工程指示 / 要求簡箋(E.I.)

工程指示編號：EI / 2248 / 20

工程名稱：亞皆老街中電

工程項目：佛沙窗 QC 檢查和顧問簽收

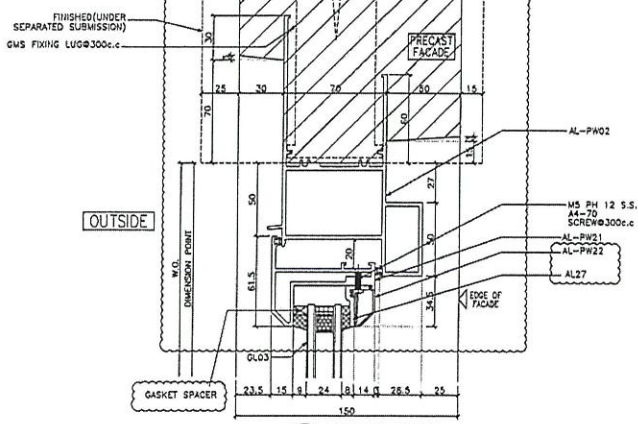
铝窗没加固，不便  
于搬运

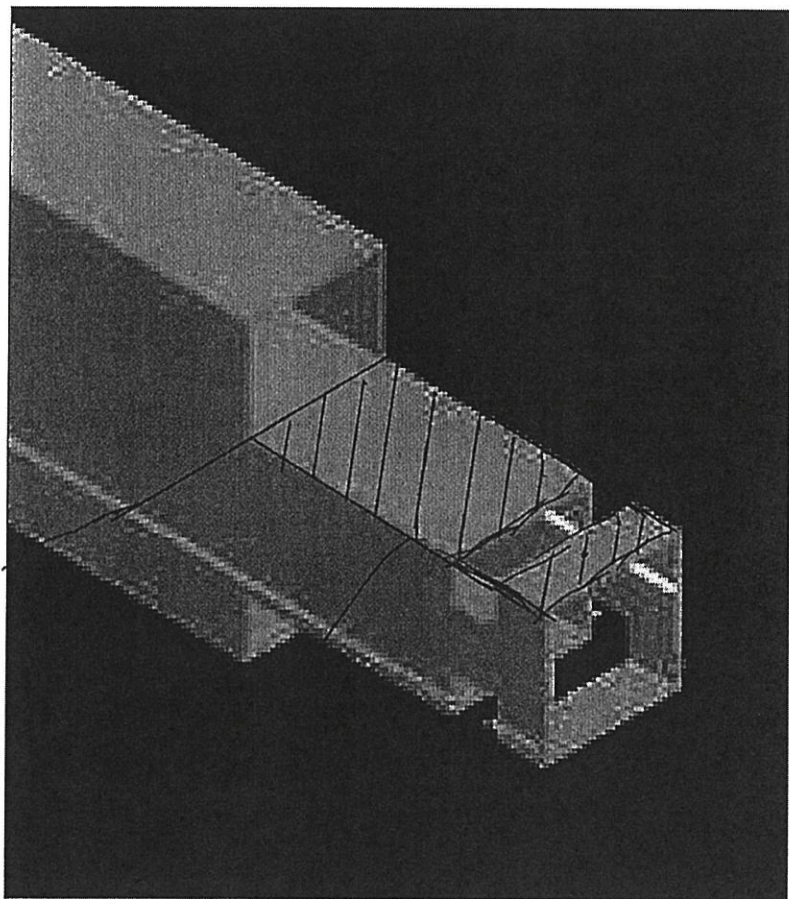
△ 此位置是龍骨位置避位；  
 開避位後會變為M11料(沒色)；  
 此位置會埋於石架，現會要求廠家  
 用油立青油以代替這噴顏色。

按附件大家會看到有油漆脫落的位置是在於龍骨避位位置-此位置會被石矢及裝飾瓦片/石完全遮蓋(開避位後經鋁窗廠自行返噴色油)，而不是鋁窗落佛沙後的見光位置，本司會要求鋁窗加工廠於避位位置塗上瀝青油而不是返噴色油.
